MODEL 244 GX, 250 RX, 165 RX

ATTACHMENT OF FLEXIBLE SHAFT TO THROTTLE LEVER

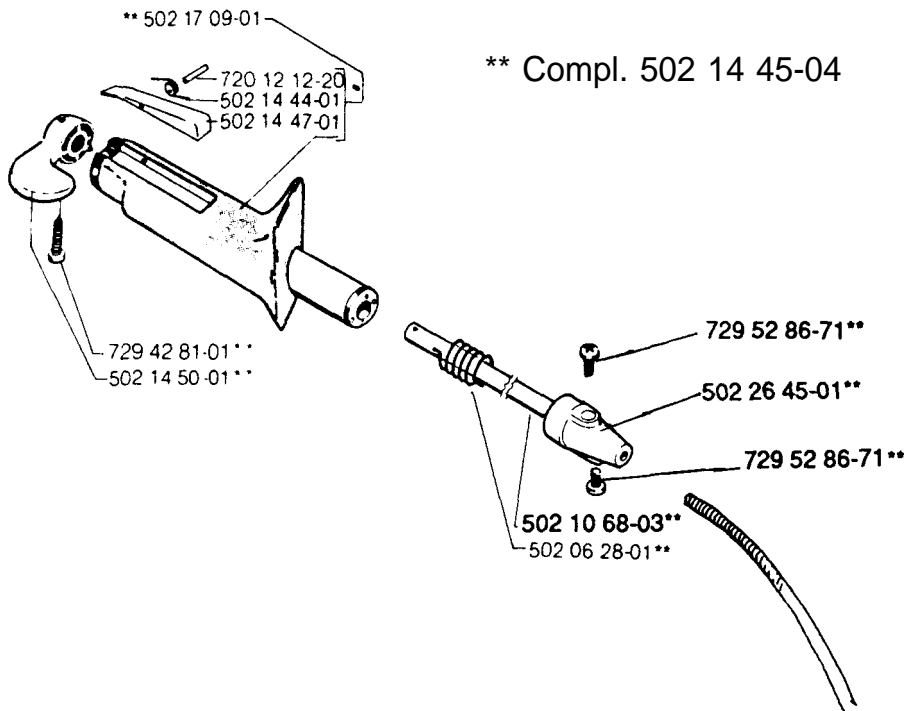
In order to permit simpler and more reliable adjustment of the throttle control the tensioning sleeve has been replaced by screws.

NOTE! Make sure that the throttle flap opens fully when the throttle is set to full. Otherwise there is a risk that when you adjust for the recommended maximum speed that the fuel/air mixture will be too lean, resulting in damage to the cylinder or piston. See the instruction book for directions on how to adjust the carburettor.
